Report to Sydney West Central Planning Panel

Panel reference	2017SWC006
DA number	SPP-16-04463
Proposed development	Subdivision, new public roads, 9 x residential flat buildings and a neighbourhood shop
Street address	41 Terry Road, Rouse Hill
Applicant	Sutherland and Associates Planning Pty Ltd
Landowner	Denvell Pty Limited
Date of DA lodgement	9 December 2016
Number of submissions	None
Regional development criteria (Schedule 4A of the EP&A Act)	Capital investment value (CIV) over \$20 million (DA has CIV of \$95.1 million)
All relevant s79C(1)(a) matters	<ul style="list-style-type: none"> • Sydney Regional Environmental Plan No. 20 – Hawkesbury-Nepean River • State Environmental Planning Policy (State and Regional Development) 2011 • State Environmental Planning Policy No. 55 – Remediation of Land • State Environmental Planning Policy No. 65 – Design Quality of Residential Apartment Development • State Environmental Planning Policy (Building Sustainability Index: BASIX) 2004 • State Environmental Planning Policy (Sydney Region Growth Centres) 2006 • Blacktown City Council Growth Centre Precincts Development Control Plan 2016 • Draft Central City District Plan

Report prepared by

Figure 2: Extract from the technical verification of the proposed plenum ducts to be applied to 13 apartments to achieve natural cross ventilation.

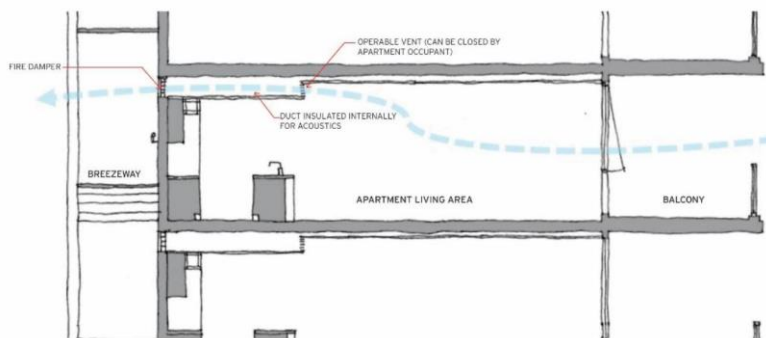
- a. To achieve natural cross ventilation to at least 60% of the total of 332 apartments, as required by Part 4B Natural Ventilation of the ADG, the following alternate techniques are proposed:
 - 13 apartments on the Ground Level, Level 1 and Level 2 rely on the use of plenum ducts, being 4 % of the apartments. Plenum ducts are a space

between the structural ceiling and the dropped ceiling that can facilitate air circulation

- 42 apartments on Level 3 (the top level) rely on rooftop ventilating skylights, being 13 % of the apartments.
- b. The Applicant has submitted technical verification of the effectiveness of the proposed plenum ducts to provide natural cross ventilation, prepared by Windtech Consultants and provided at Attachment 12. Figure 2 below demonstrates this design.

- c. The overall development is considered to achieve a suitable level of amenity through natural cross ventilation, subject to these alternate techniques. Subject to conditions to ensure that these ventilation methods are appropriately installed and reflect the relevant fire safety and acoustic requirements, residents' access to natural cross ventilation is acceptable in this instance.
